# **SUSITNA HYDROELECTRIC PROJECT**

(PROJECT NO. 7114-000)

**RESPONSES TO  
THE DEPARTMENT OF THE INTERIOR  
COMMENTS ON LICENSE APPLICATION**

February 15, 1984

FIGURE E.1.85

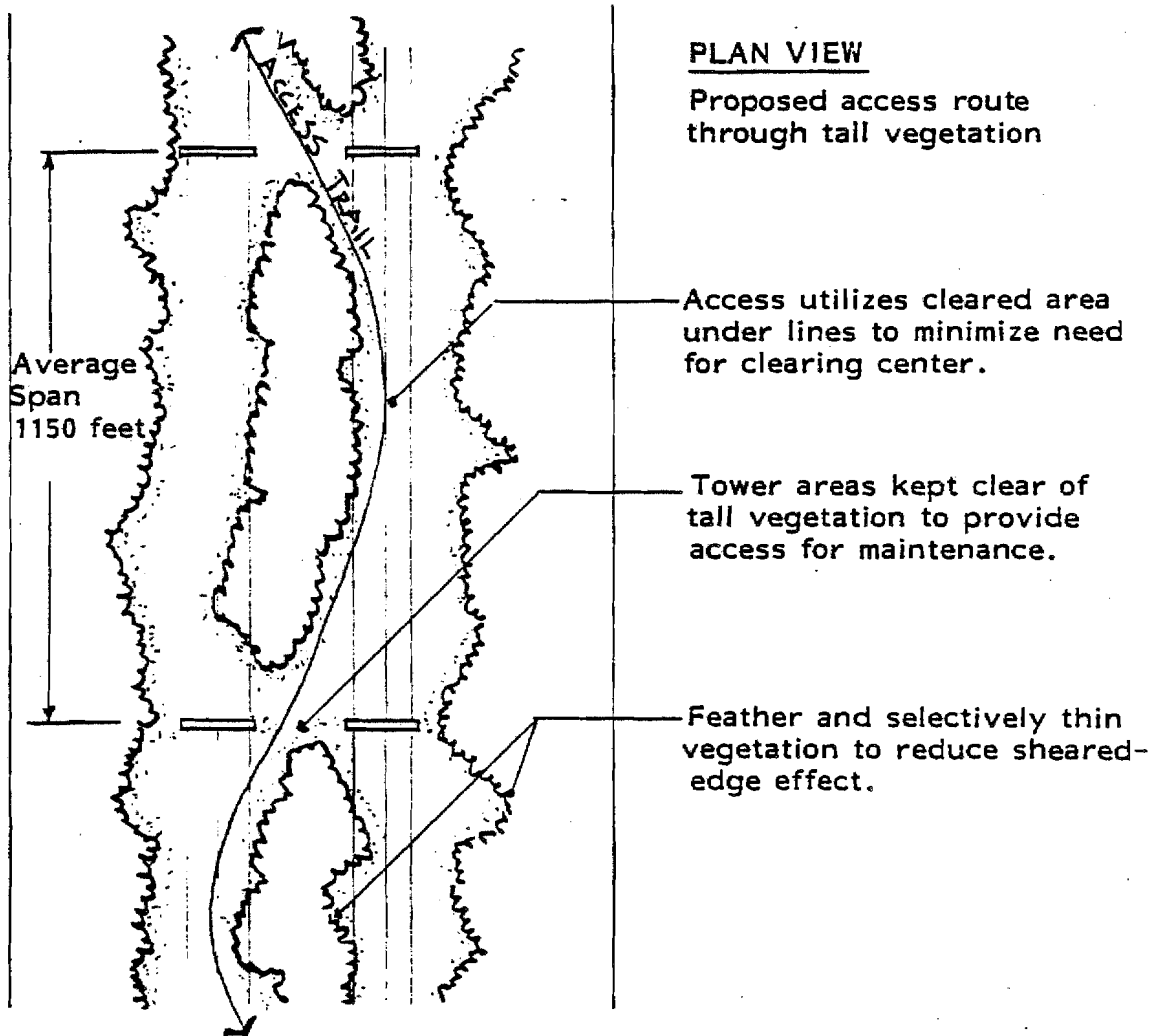
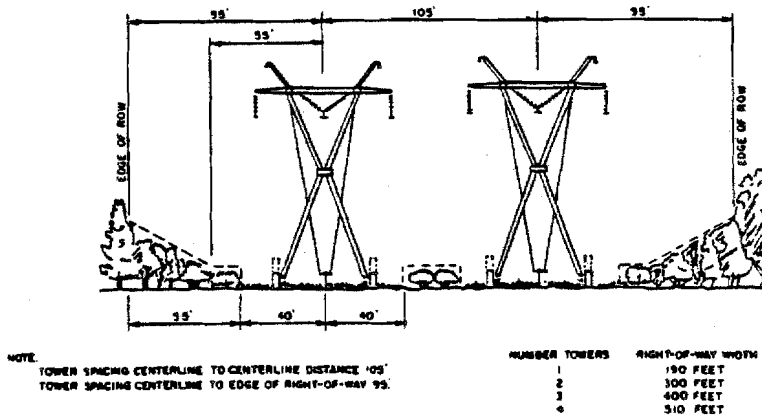
"Page E-3-493: 4.3.4 - Transmission Lines: Paragraphs 2 and 3: To minimize clearing requirements along the transmission corridor, we recommend that the 25-foot maintenance access trail be adjacent to the towers, in the area where vegetation will be kept to a minimum height. The applicant should provide the anticipated schedule and height criteria for safely maintaining vegetation clearing along the line. Opportunities to alter the schedule to maximize production of early successional vegetation types for moose and black

"The referenced map of the transmission corridor (Figure E.3.37) is incomplete. We suggest addition of an overview map showing the locations of Figures E.3.48 through E.3.52.

Final routing of the access trail for the transmission line will be determined by site specific data obtained through field investigations during the detailed construction planning for the line. It is anticipated that in areas of tall vegetation and, where allowable, due to terrain conditions, the access trail will follow the pattern shown in the attached Concept For Construction/Maintenance Access. Anticipated clearing heights are described in FERC License Application Exhibit E, Chapter 9, page E-9-48. Presently, the schedule for maintaining vegetation height standards is anticipated every ten years at a maximum. Final schedules for maintenance of the right-of-way will be determined by the operating contractor and will provide for flexibility depending on identified circumstances. FERC License Application Figure E.3.37 shows only the transmission line route between Watana and Gold Creek (the immediate project site). The complete transmission line route is referenced in FERC License Application Exhibit G, Plates G.30 through G.52. These maps are keyed to an overview index map shown in Plate G.4.

DEVIL CANYON  
SLOPE STABILITY MAP

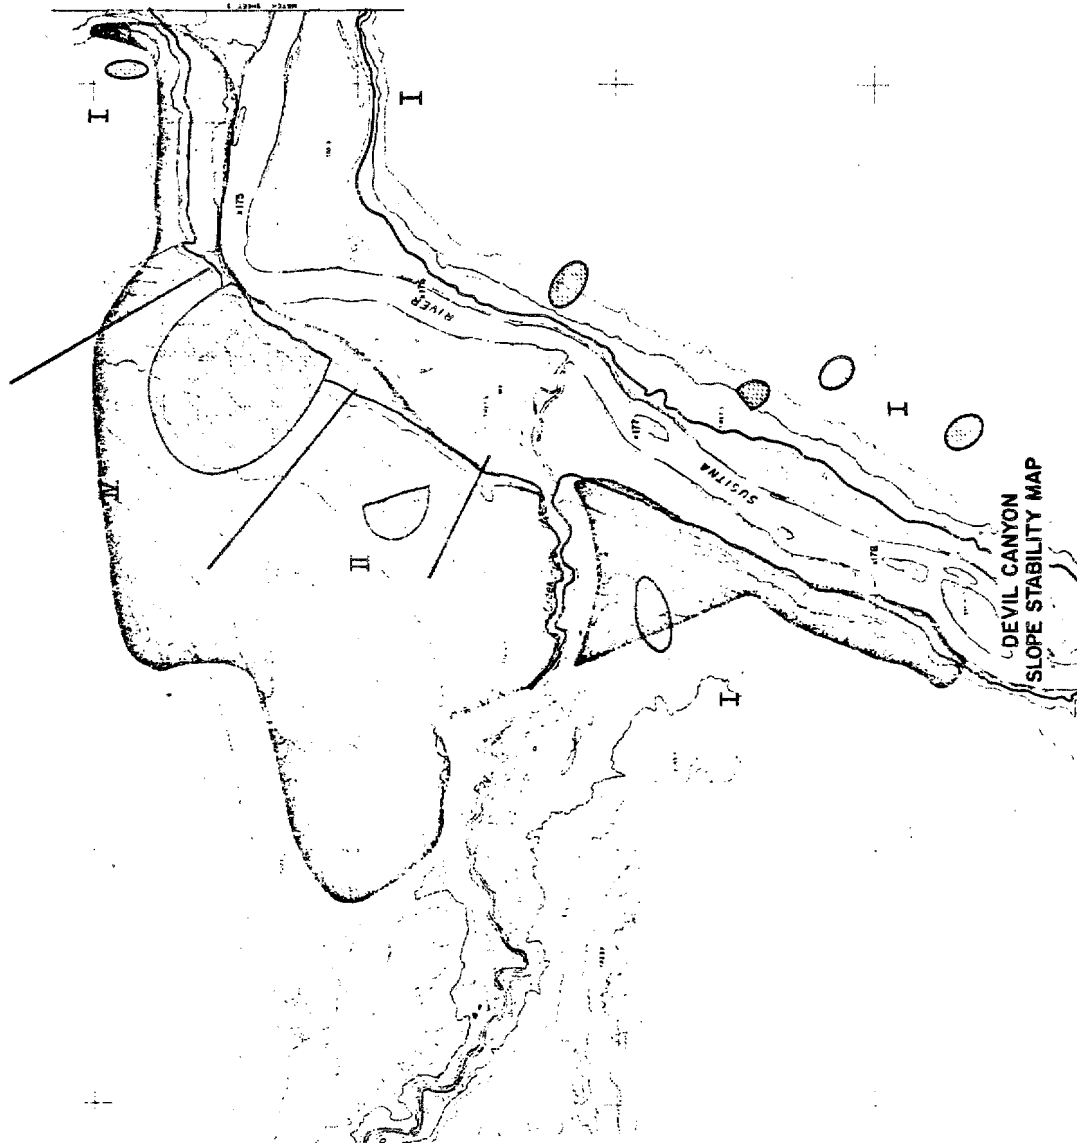
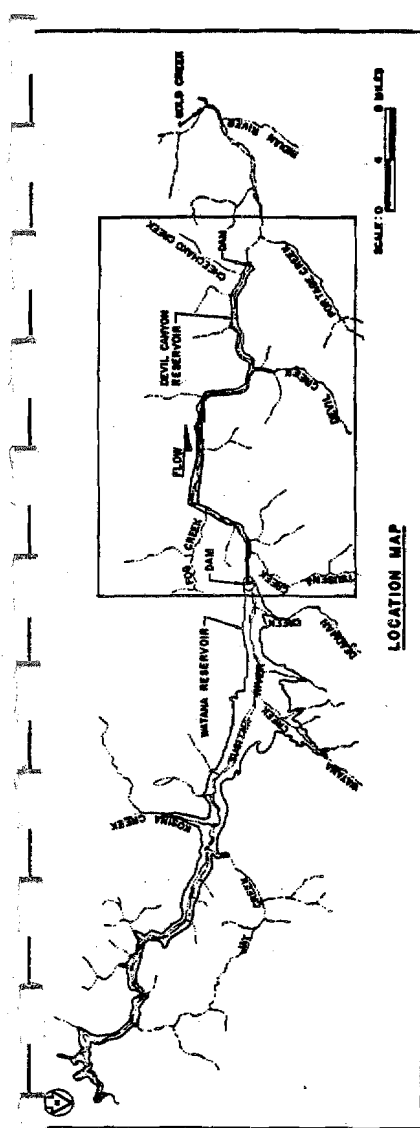
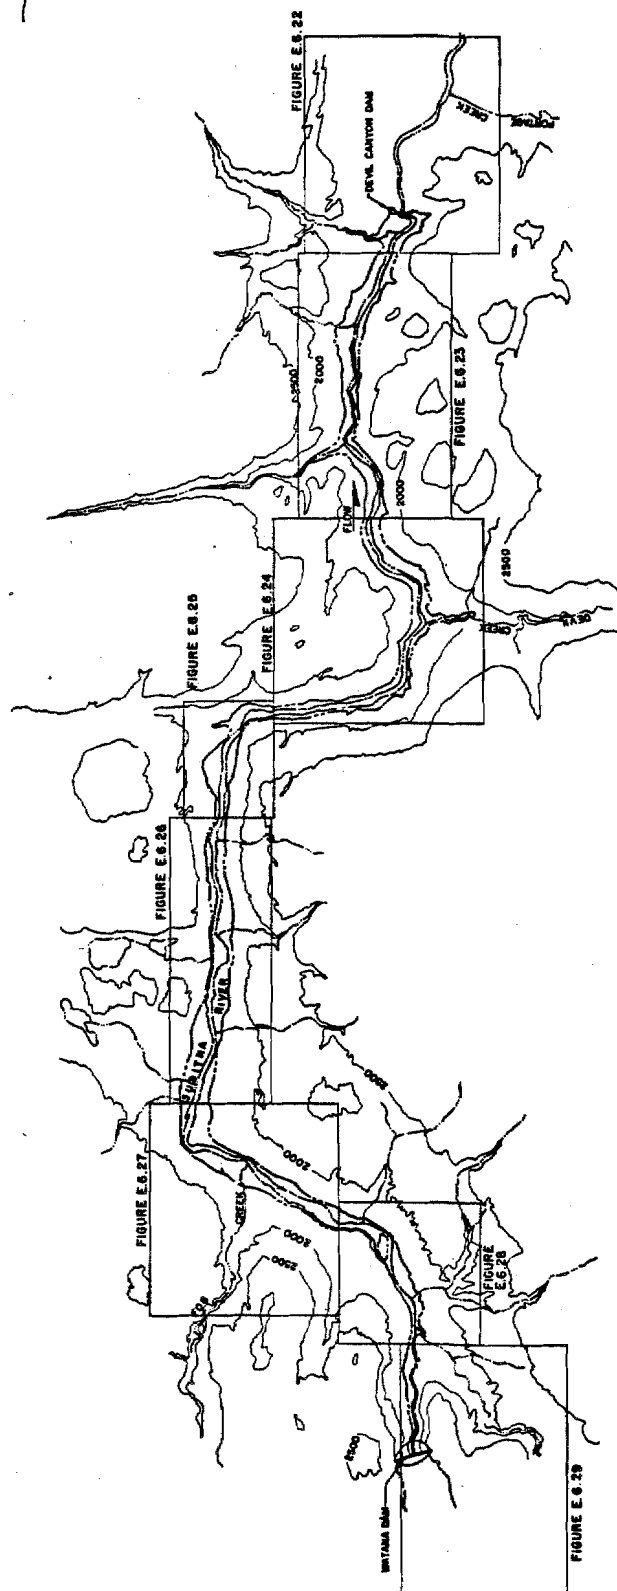
"Page E-3-242: Filling and Operation: Paragraph 3: We find no delineation of the large landslide at RM 175 on Figure E.3.3. as referenced here."

The figure reference for the old landslide at River Mile 175 should be: FERC License Application Exhibit E, Chapter 6, Figures E.6.27. A copy of that Figure is attached.
